# CITY OF LONGWOOD

## ADDENDUM II

June 6, 2016

Subject: IFB 04142016-GPK Church Ave Pavement Management

Add: FDOT Index 6011

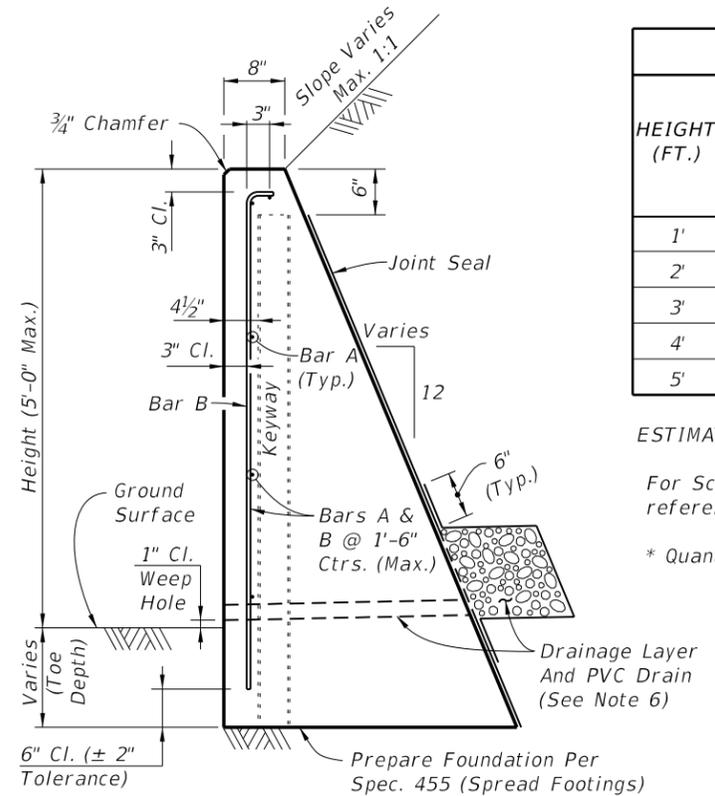
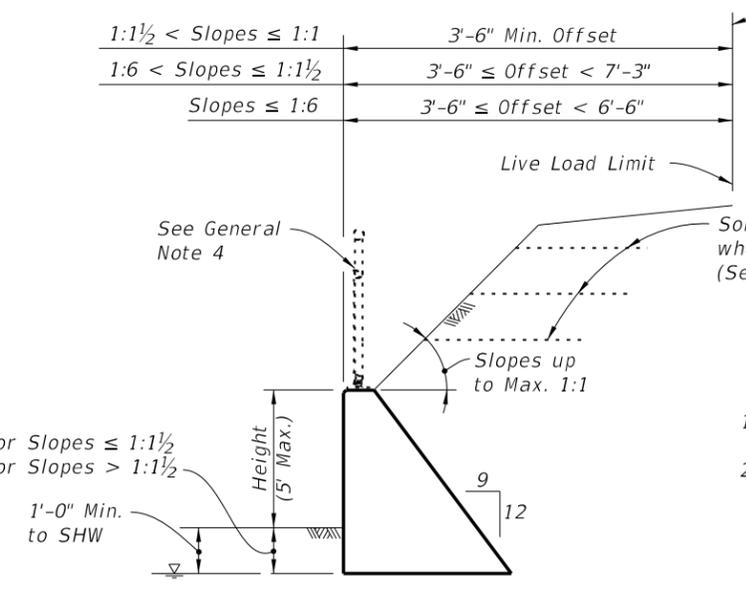
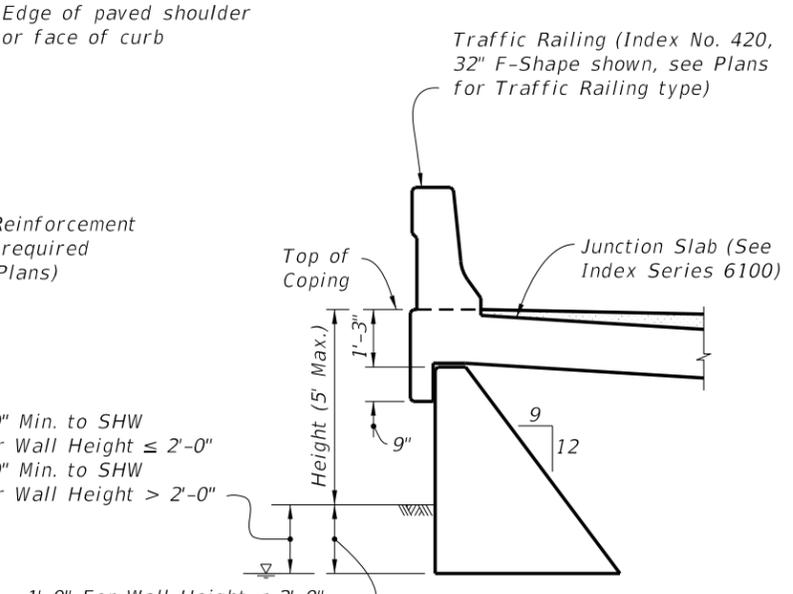
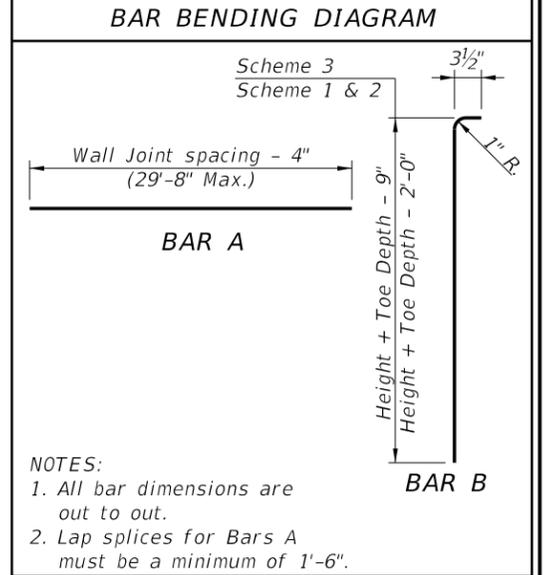
1. If the engineer wants the wall replaced in kind, can a detail be provided so we can properly estimate the wall? There is a gravity wall detail on 1 sheet 10.01. I assumed the detail on sheet 10.01 is the type of wall being constructed under pay item no. 110-20.

5. The city has a pay item for Furnish and Install Gravity Wall, Brick Faced. There are no details in the plans that specify what type of "brick face" should be on the gravity wall. Is the City expecting the contractor to install actual bricks over the exposed wall area?

- a. Answer: Use the FDOT index 6011 (See attached). Use real brick to cap the wall and a thin brick veneer for the face. The brick selection will need to be approved prior to installation to ensure that it matches the existing wall to remain.

- a. Answer: The intent is that the existing retaining wall, that is being removed, will be replaced in kind in the new location. Actual bricks is the expected material. Other material that give the same aesthetic look will be considered.
